**WORK PLAN
REMEDIAL INVESTIGATION/FEASIBILITY STUDY
BB&S TREATED LUMBER CORPORATION SUPERFUND SITE**

**NEW YORK STATE DEPARTMENT OF ENVIRONMENTAL CONSERVATION
DIVISION OF HAZARDOUS WASTE REMEDIATION**

Re: Response to Comments on BB&S Work Plan

Re: WA#D002852
Response to Comments on BB&S Work Plan

MALCOLM PIRNIE, INC.
0266-323-100
FIGURE 1

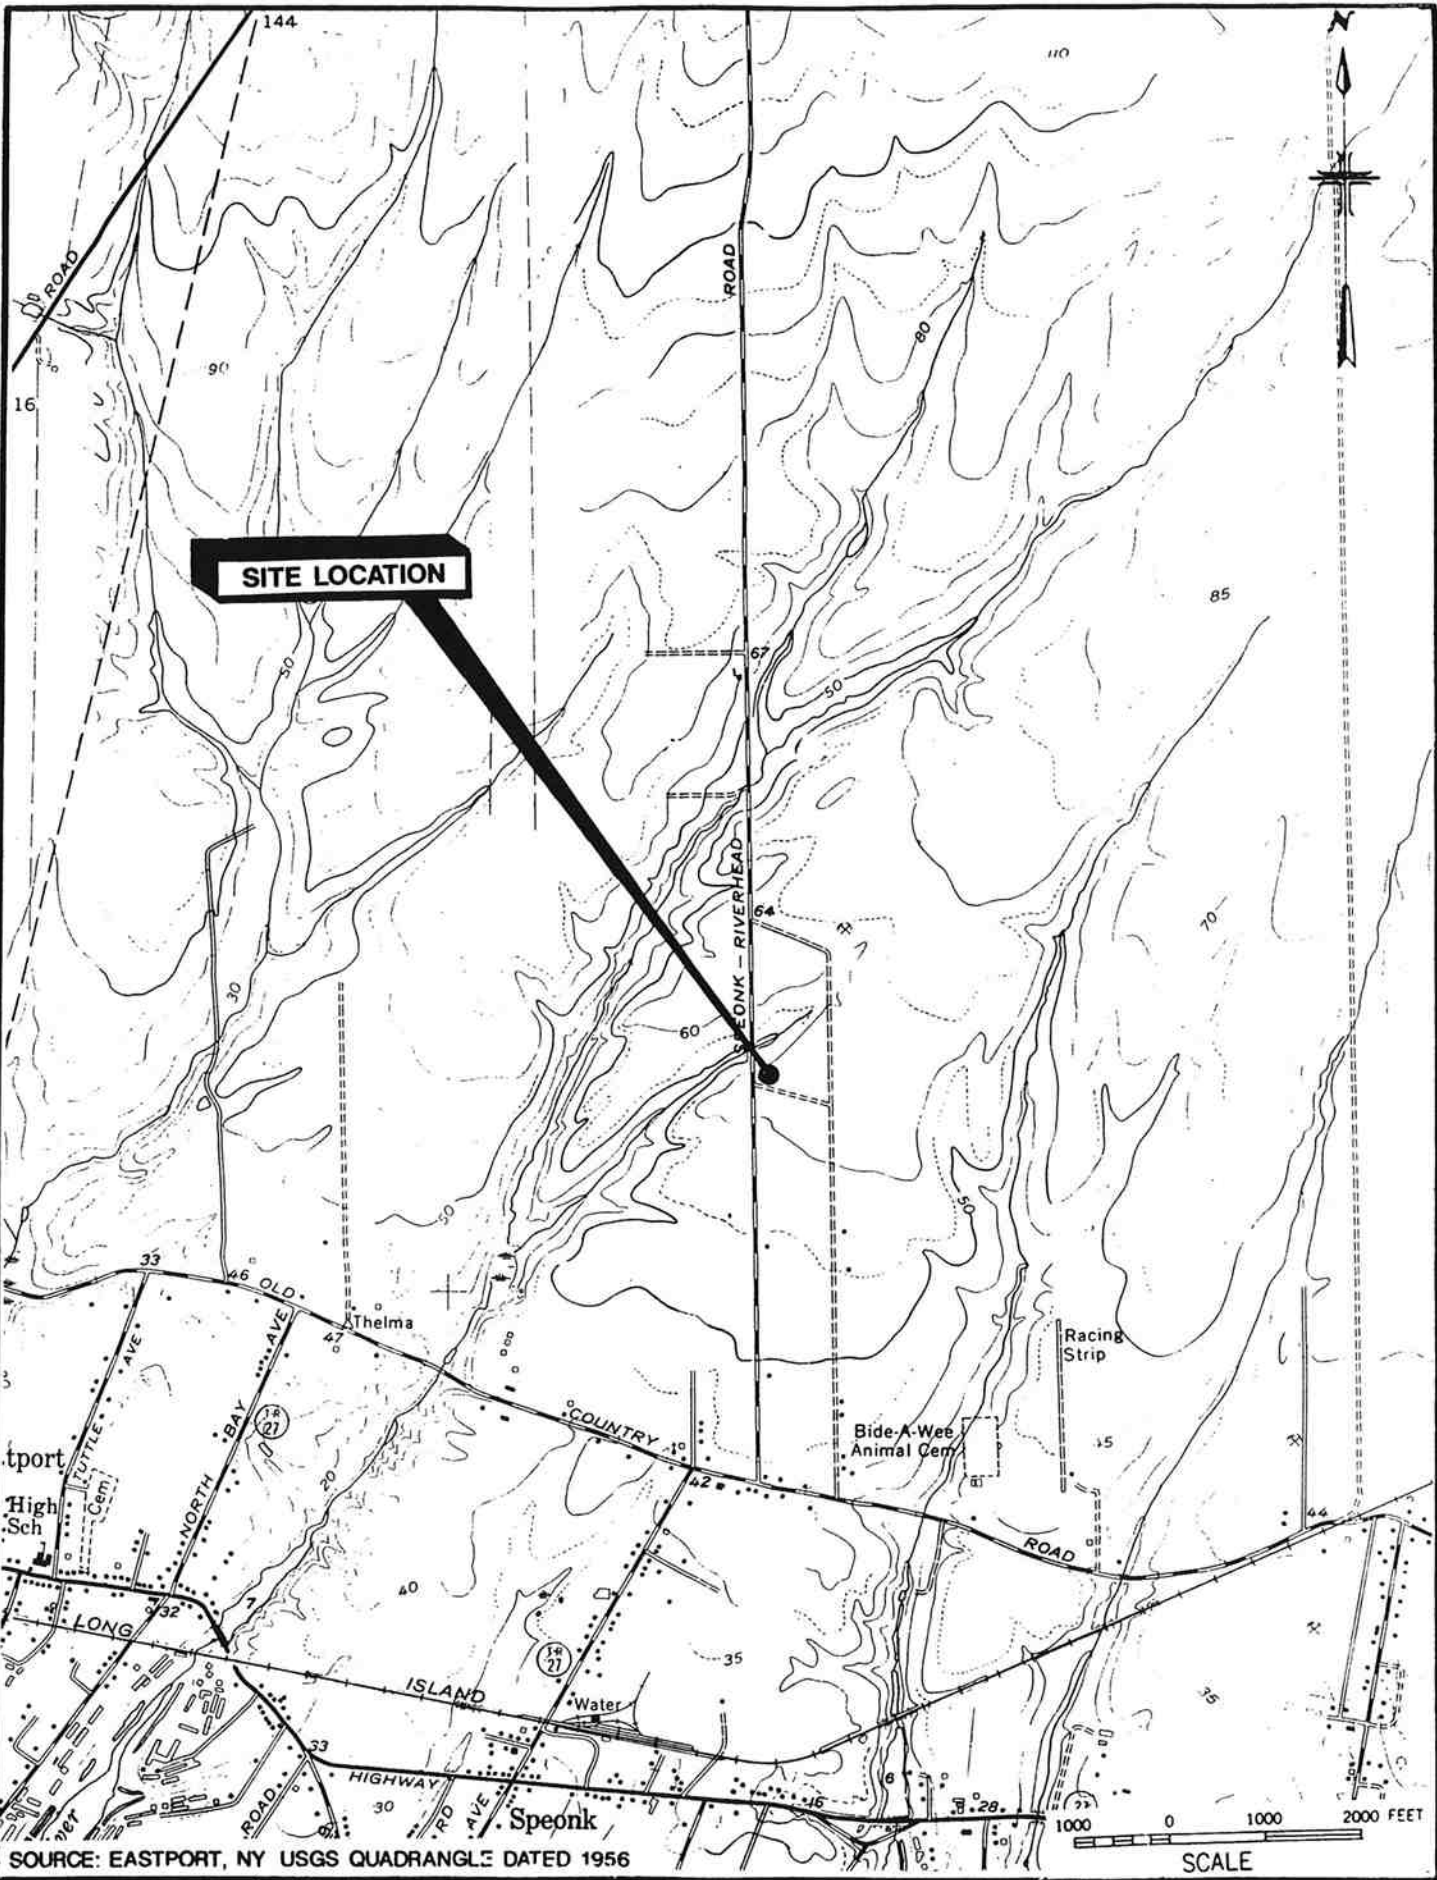
- Figure 1 in the Work plan and Appendix B, the Health and Safety Plan has been updated.
- The holding time of TOC has been changed from 2 days to 26 hours in Table 3-2.
- The project schedule in Section 4.0 has been updated with a total of 3.5 months cut from the project.
- The Health and Safety Plan has been revised to include the requirements of 29CFR1910.1080; requirements for inorganic arsenic sites. Our plan now includes personal air monitoring for all Malcolm Pirnie employees that will be on site. We have notified our subcontractors of this proposed change to our Health and Safety Plan and informed them that they would be responsible for conducting their own air monitoring. Costs associated with this additional monitoring have been included in the budget.
- Page 11 of Appendix A has been reworded to include the maintenance of ELAP certification.

It was also agreed that the pretest water level monitoring would be cut from seven to four days. This has not been addressed. One justification MP uses for seven days of water level monitoring is that there is a sand mine and well near the site that may be affecting the study area. On Figure 1 of the Work Plan a gravel pit is shown ½ mile to the south-southeast of the site. A well in the Upper Glacial Aquifer that far away would have to produce massive amounts of water to cause significant interference in the aquifer test.
